**SAFETY EVALUATION BY  
THE OFFICE OF NUCLEAR REACTOR REGULATION  
RELATED TO NRC GENERIC LETTER 2004-02,  
NUCLEAR ENERGY INSTITUTE  
GUIDANCE REPORT  
(PROPOSED DOCUMENT NUMBER NEI 04-07),  
“PRESSURIZED WATER REACTOR  
SUMP PERFORMANCE EVALUATION METHODOLOGY”**

The Nuclear Energy Institute (NEI) submitted (proposed document number NEI 04-07) "Pressurized Water Reactor Sump Performance Evaluation Methodology" (NEI, 2004a, referred to herein as the Guidance Report or GR), for review by the U.S. Nuclear Regulatory Commission (NRC, the staff). NRC approval of this methodology guidance would allow licensees of pressurized water reactors (PWRs) to use the document in their responses to recently-issued NRC Generic Letter 2004-02, "Potential Impact of Debris Blockage on Emergency Recirculation During Design Basis Accidents at Pressurized-Water Reactors" (GL-04-02), as the cited NRC approved methodology for their evaluation of plant-specific sump performance. The Generic Letter identifies inadequacies in previous approaches for modeling sump screen debris blockage and related effects, such that the staff no longer considers many licensing-basis analyses acceptable for confirming compli

**Figure 3-1. Comparison of GR Isobar Map with Isobars from Independently Evaluated ANSI Jet Model**

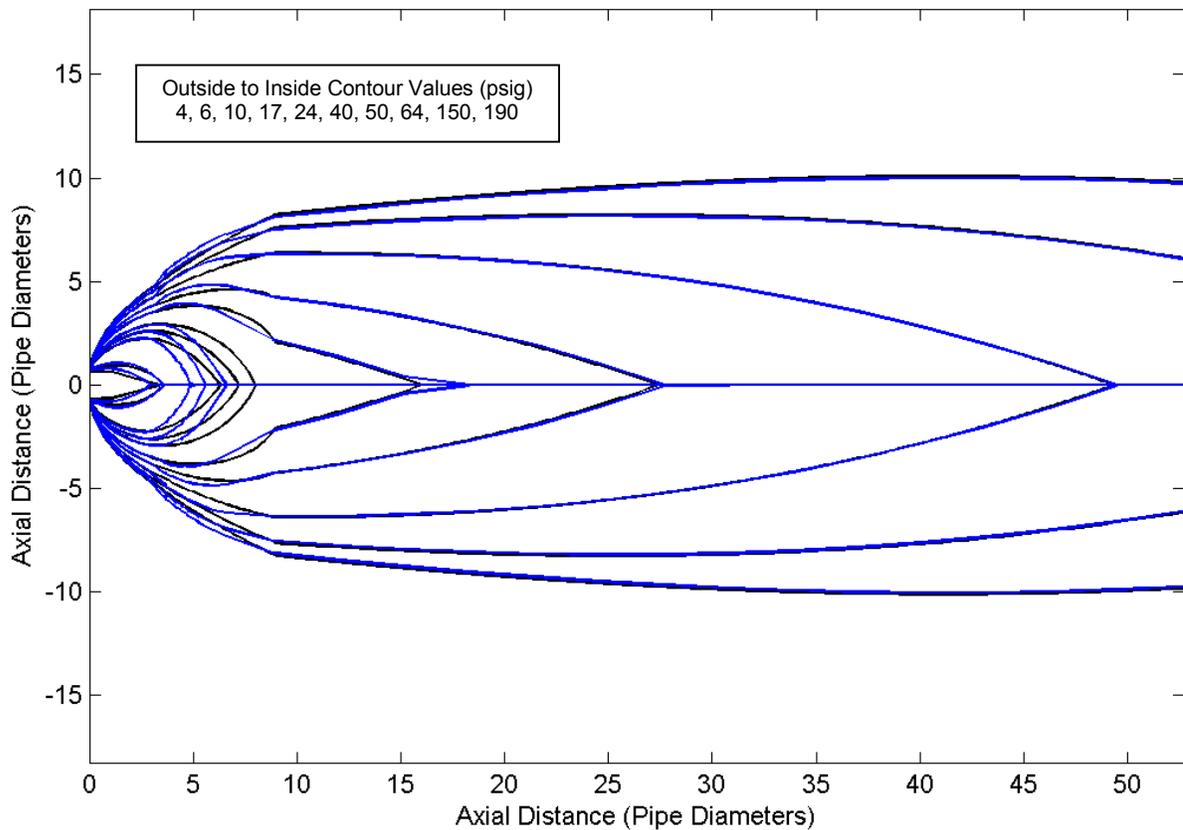
Table 3-1 is offered in the GR as a mechanism for matching experimentally determined damage pressures with "calculated" values of volume-equivalent spherical ZOI radii. Presumably, the calculations were performed in the manner described in Appendix D of the GR, but no cross reference or explanation is offered. Appendix D cites an evaluation of the ANSI/ANS 58.2-1988 that was used to generate spatial jet pressure contours, but no insights are offered in the GR for how to interpret the resulting pressures with respect to material damage.

In order to confirm that the ANSI jet model was implemented properly the model was independently programmed and the results compared with the isobar map tabulated in Table D-1 of the GR. This comparison is shown in Fig. 3-1 where the blue contour lines represent the GR evaluation of a break at 2250 psia and 540 °F and the black contour lines represent a reference cold-leg break at 2250 psia and 530 °F. See Appendix I of this SER for an explanation of the independent calculation and additional guidance on interpreting results of the ANSI jet model.

Good agreement is seen between the calculations for downrange behavior (Zone 3), but discrepancies exist in Zones 1 and 2. It appears that contour termination points on the centerline are not accurate and that the quadratic behavior of the Zone 2 isobar equations is not implemented correctly. These differences will have a negligible effect on volume integrals for jet pressures less than 20 psig, but may become more of a concern for higher pressures near the break. To quantify the magnitude of the difference, Table 3-1 below presents a comparison of ZOI radii computed from both methods. In particular, the GR approach may not have preserved the system stagnation pressure throughout the volume of the liquid core region as specified by the standard. However, the GR recommended values essentially bound both sets of calculated values.
